EASA	COMMENT RESPONSE DOCUMENT
	EASA CRD of Proposed Special Condition for Lights for Free Manned Balloon Flights at Night Issue 1

Paragraph N°: AMC CS 31HB / GB.65(b)(3)

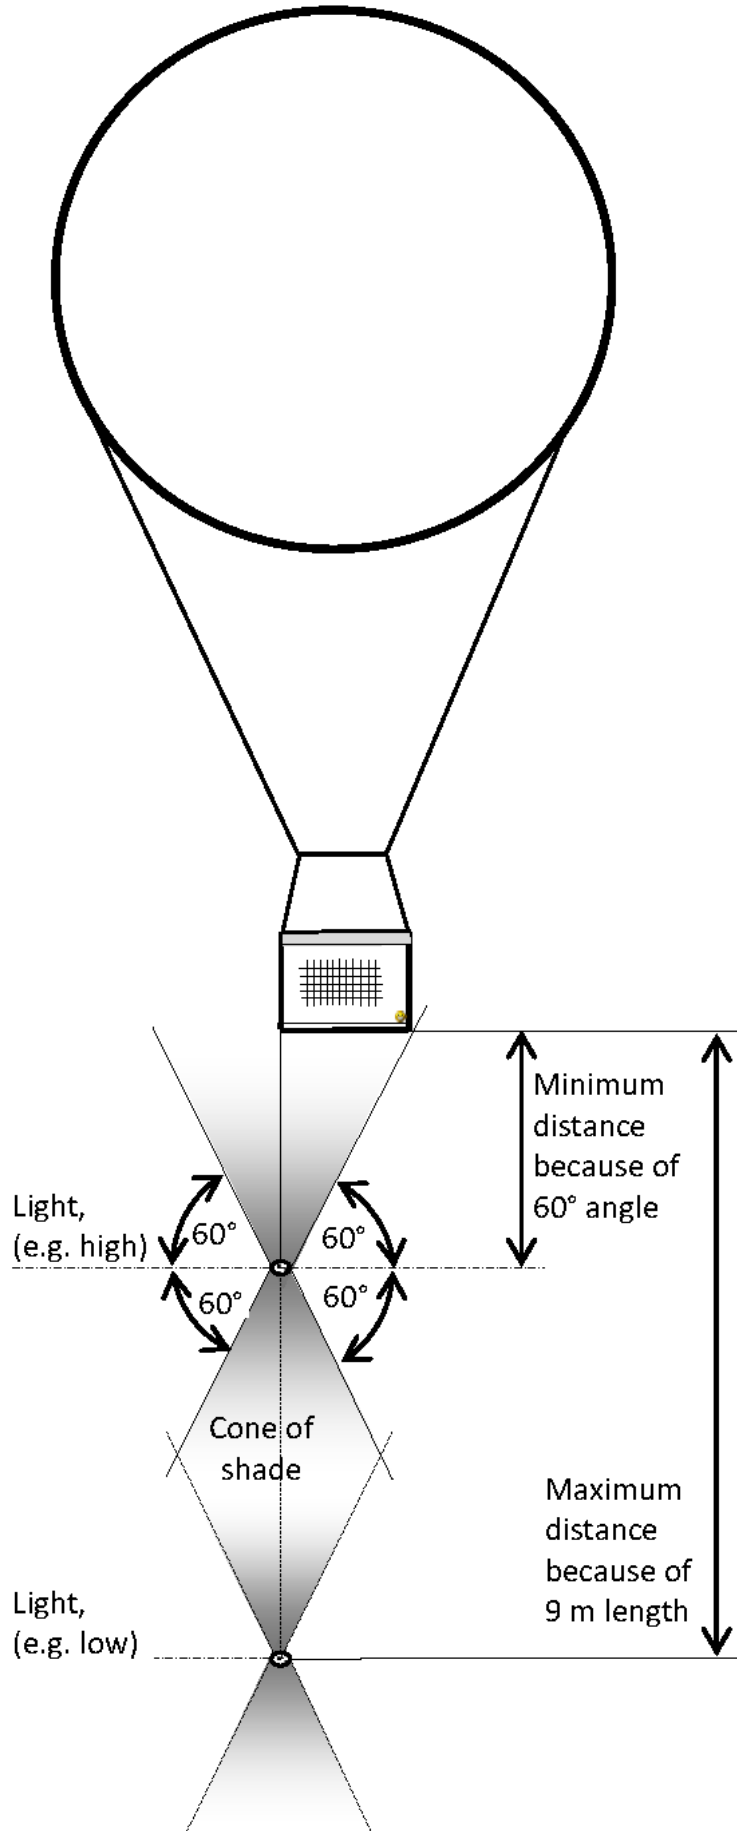
Comment: A maximum AND MINIMUM distance below the basket is required for the Anti-Collision light.

Justification: A minimum distance is required in order to separate the basket and light.

Proposed Text: The Anti-Collision light shall be suspended not less than 5 metres and not more than 9 metres below the basket, or if there is no basket, below the lowest part of the balloon.

EASA response:
The Special Condition comprises the "±60° vertical coverage" which assures visibility for ascending/descending traffic.
The minimum vertical distance results from the geometric arrangement of the light. This additional flexibility allows also for unconventional designs not necessarily suspended beneath the basket.
The drawing similar to the one below will be added to the AMC to clarify the minimum/maximum distance.
